UNITED STATES PATENT AND TRADEMARK OFFICE

Office Action Summary	Application No. 10/714,225	Applicant(s) MULLANEY, MICHAEL W.	
	Examiner CHRISTIAN SEVILLA	Art Unit 3775

DETAILED ACTION

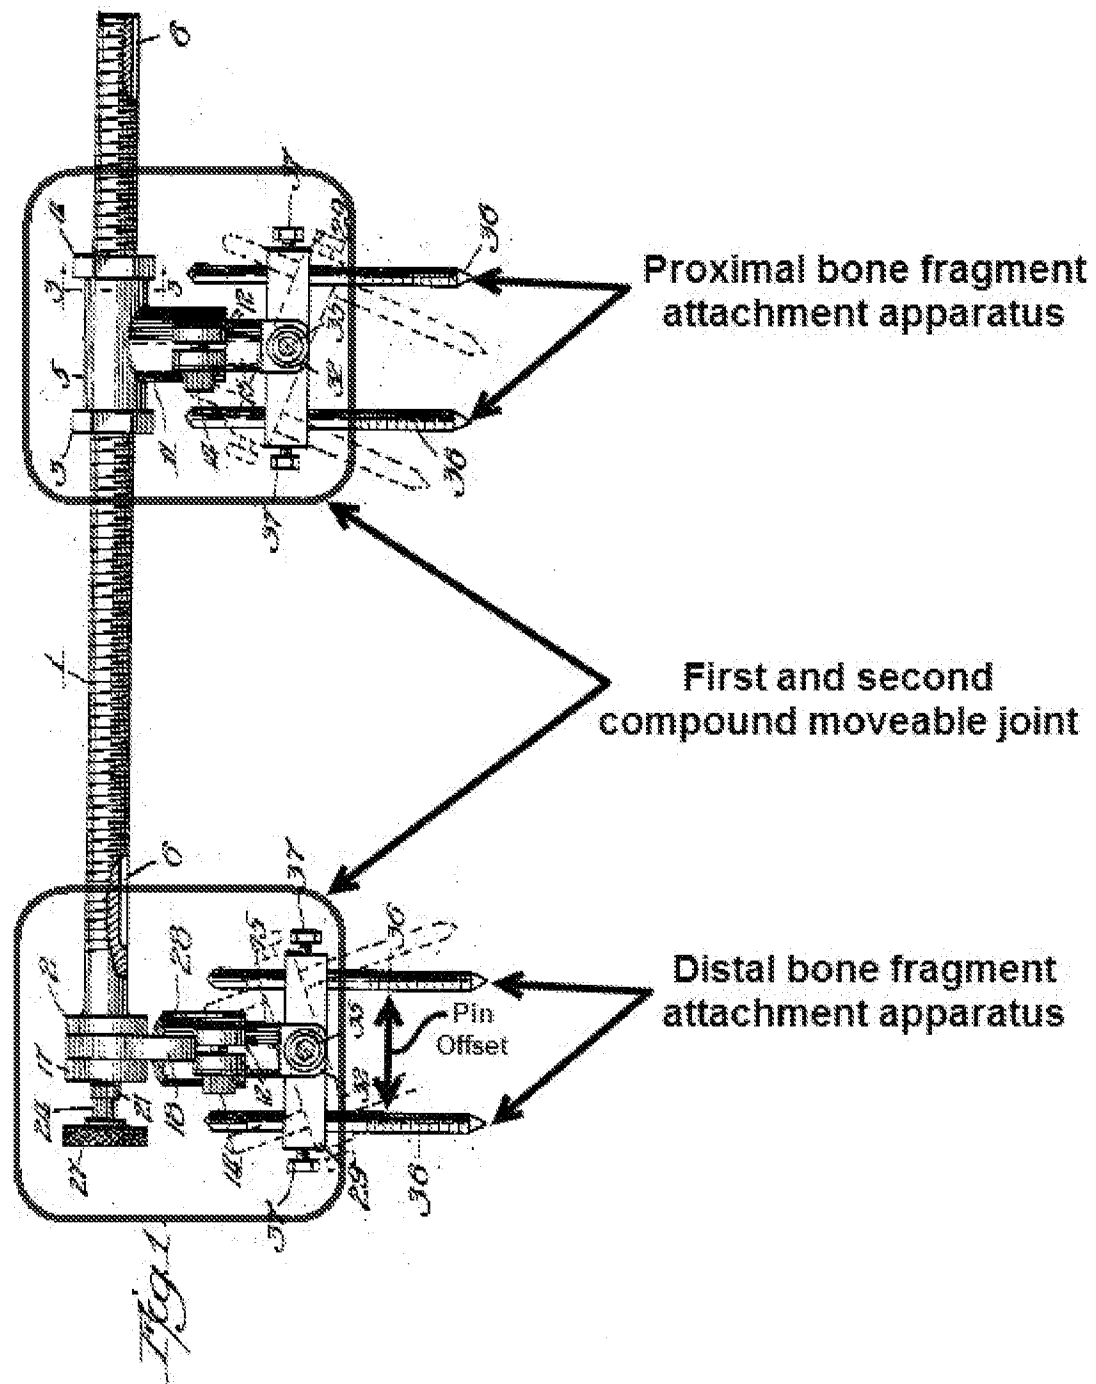
Regarding claim 8, Ettinger discloses a) characterizing a mounting condition for a proximal bone fragment attachment apparatus (36) and a distal bone fragment attachment apparatus (36), as shown in annotated Fig. 1 above; b) determining a first

Regarding claim 9, Ettinger discloses the deformity-correcting fixator comprises a unilateral fixator including a first and a second compound movable joint, as shown in annotated Fig. 1 above, wherein each compound movable joint provides deformity correction in two degrees of freedom, and a strut assembly, and a strut assembly which provides a third degree of freedom for each compound movable joint.

Regarding claim 12, Ettinger discloses parameters for offsets and joint rotations {zero values if they do not exist} of joints and clamps {e.g., the first and second compound moveable joints in annotated Fig. 1 above}.
